Western LNG Project

VOL. III-COMMENTS AND APPENDICES

Final Environmental Impact Statement

Pacific Alaska LNG Associates
Docket No. CP75-140

Figure 1. Map showing Government Point and Cojo survey sites.

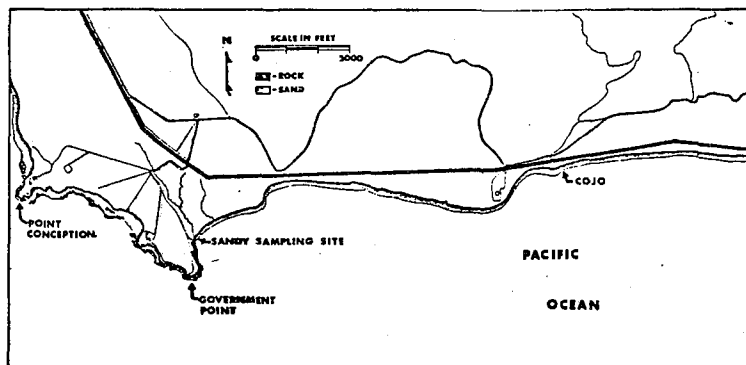
I have conducted a personal reconnaissance of the intertidal area at the proposed Point Conception site (Figure 1). During the last ten years I have conducted, and directed, ecological surveys at over 70 sites on the California mainland from Estero Bay to the Mexican border, and I have personally visited all but one or two of those sites. On the basis of my observations, there is no other ecologically similar intertidal area to that found in the Cojo site area and the coastline for approximately three miles on either side.

Figure 2. Intertidal profiles at the proposed site of the LNG terminal (Cojo) and at Government Point.

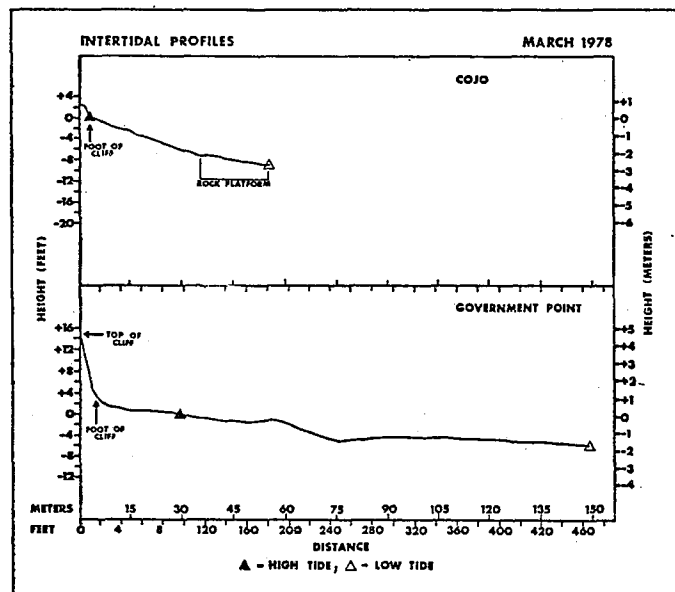
I base this statement on observations made at the Cojo site and a site just south of Government Point in March of this year (Figure 1). Profiles were taken across the intertidal zone at both sites (Figure 2). Sand had been lost from the Cojo site, as noted on previous winter surveys (Dames and Moore 1974, 1977) but had accumulated at the Government Point site. The length of the intertidal area at Government Point was twice that recorded at Cojo (175 feet vs. 360 feet).

The beach slope was much steeper at Cojo, about one foot in 20 feet, than at Government Point, about one foot in 80 feet. There was a rock platform exposed at Cojo and no rock platform exposed at Government Point. The difference in sandy beach area is probably an important factor. This statement is based on research by Sanders in which he showed that the number of organisms in a given area increases very rapidly with the area of available substrate (Sanders, 1968). This is not a straight line relationship but a much steeper curve.

Figure 3. The relationship between total number of species collected if samples were collected at three intertidal levels and if samples were collected using a stratified random quadrat method.

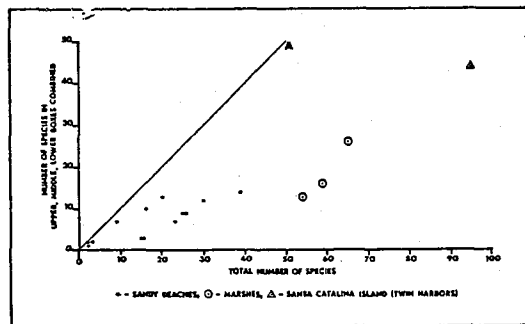
The largest sample size estimates presented by Dames and Moore (1974) were 1,000 to 1,500 ccs. Therefore, a maximum of 4,500 ccs were sampled at each three intertidal levels. The inadequacy of single line sampling methods can best be demonstrated in Figure 3. This is a comparison between the number of species collected when three intertidal levels (upper, middle, lower boxes) were sampled at the same time and same place and when a stratified random quadrat method of sampling was used (Straughan, 1977b).^{*/} The box sample at each level was 9,000 ccs or about twice the maximum size of the three quadrats collected at each intertidal level by the Applicants. A comparison of the total number of species collected at the three levels with the total number of species collected by the other method shows that the three level method becomes less and less representative of

FIGURE 12. KELP DISTRIBUTION

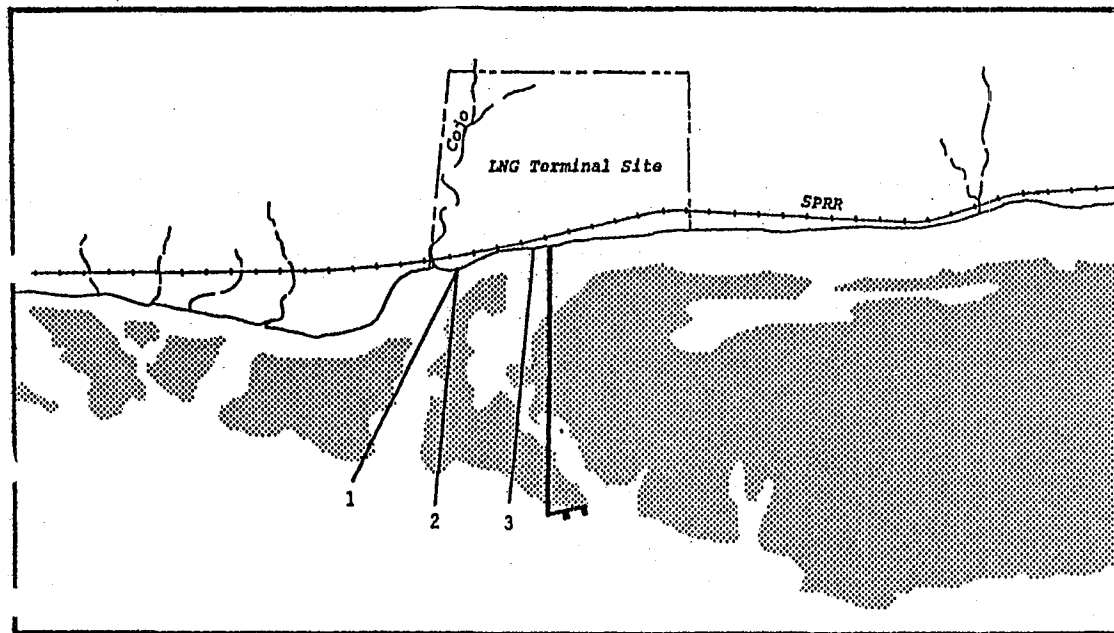
*Based on data accumulated during Kelco's many years of experience at Bed 32, Kelco's Senior Marine Biologist, Ron H. McPeak, believes that Figures 25 and 32 in the Draft Environmental Impact Statement (pages 90 and 171), while perhaps accurate depictions of the kelp canopy on the specific dates indicated, do not accurately reflect the normal distribution of kelp canopy in the area of Bed 32. A reasonably accurate representation of the normal distribution of kelp at the Point Conception site, however, is shown in Figure 12 (page 35) of Technical Report No. 26 in Support of the Point Conception LNG Facility DEIR, prepared by Arthur D. Little, Inc., and submitted to the California Public Utilities Commission in April 1978. A copy of that Figure 12 is attached as Exhibit B to this Statement.

As shown in Exhibit B to this Statement (Figure 12 of Technical Report No. 26 prepared by Arthur D. Little, Inc., and submitted to the California Public Utilities Commission in April 1978 [hereinafter "Technical Report No. 26"]), the trestle as proposed will be constructed through an area that normally has a major concentration of kelp. Two of the three seawater line alternatives being considered by the applicant are also located through significant kelp forests.

Figure 1

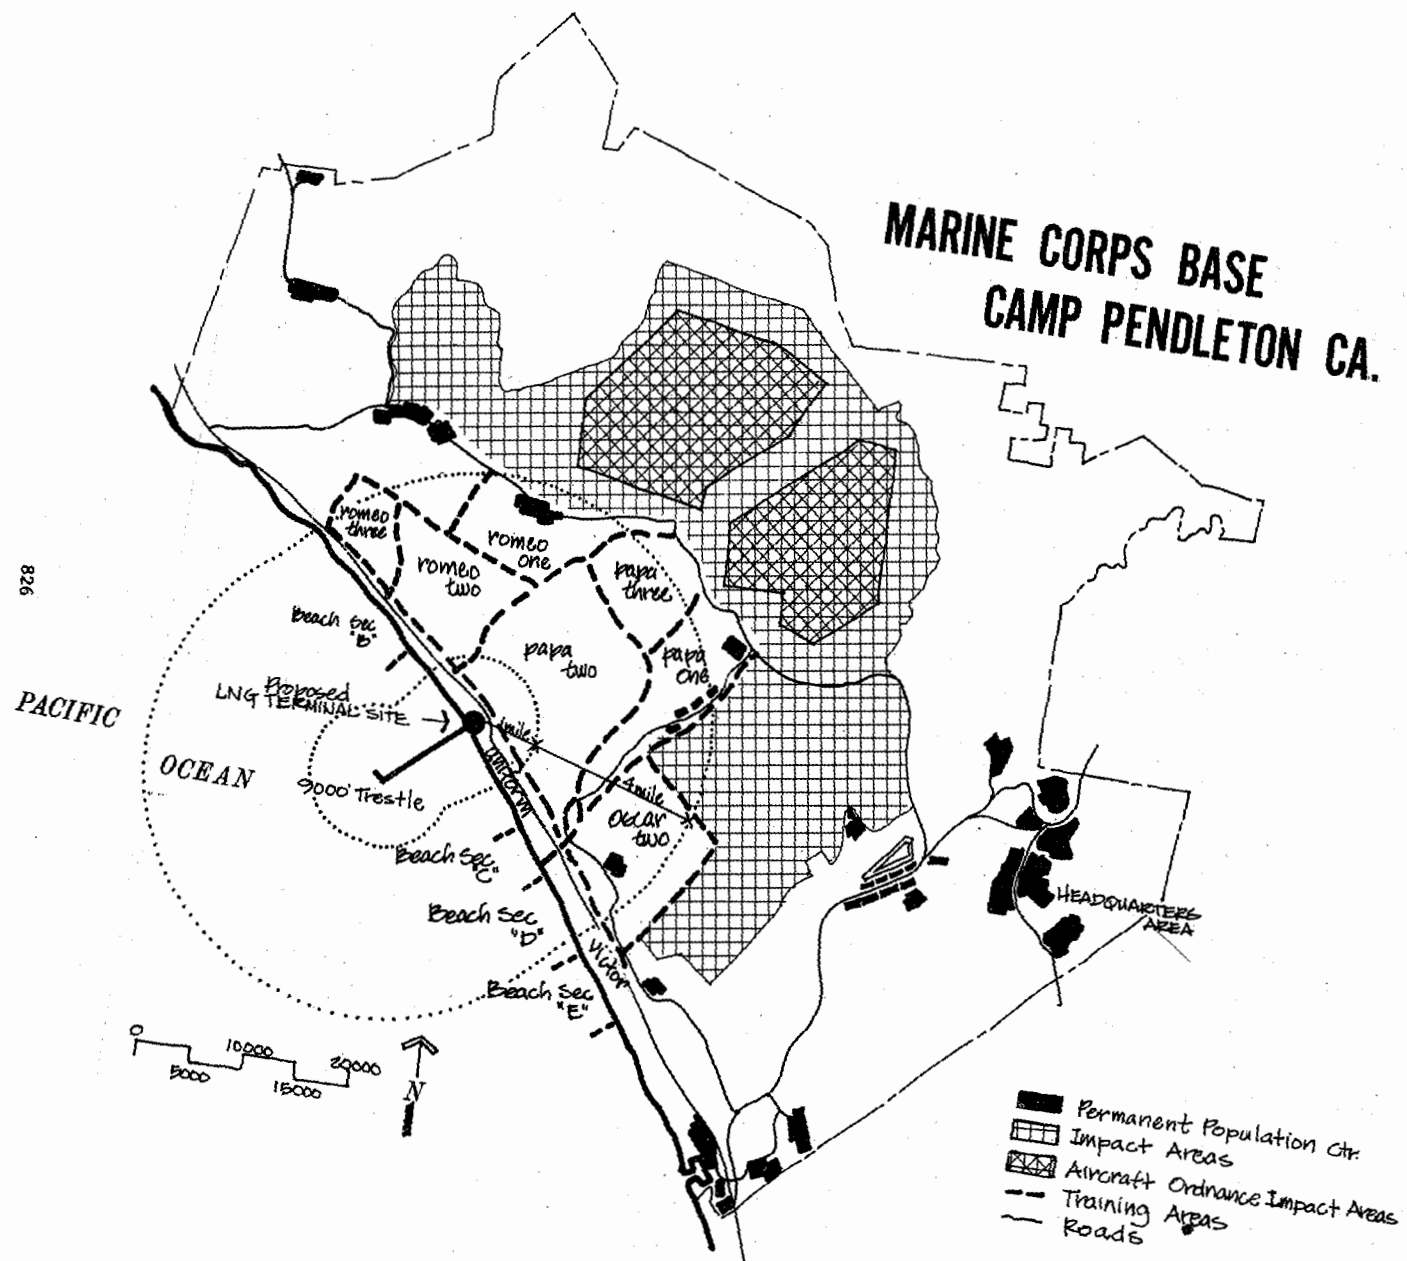
In addition to the land operations at Camp Pendleton, essential sea and air operations are conducted. The construction of a 9,000-foot trestle (associated with the LNG terminal) extending seaward would be in the direct path frequently used by naval vessels (Figure 2). The trestle would also present a major navigation hazard to transient vessels moving in shallow water parallel to the coast. This hazard would also apply to commercial and private vessels when the area is unrestricted. The Navy is also concerned about the potential of hazards and restrictions that could develop due to LNG tanker traffic in "blue water" operating areas (Figure 3). The Navy is involved in the testing and the training of personnel in the evaluation and handling of explosive ordnance in these areas. Accidents do occur, and the compounded hazard of LNG tankers would severely restrict naval operations.
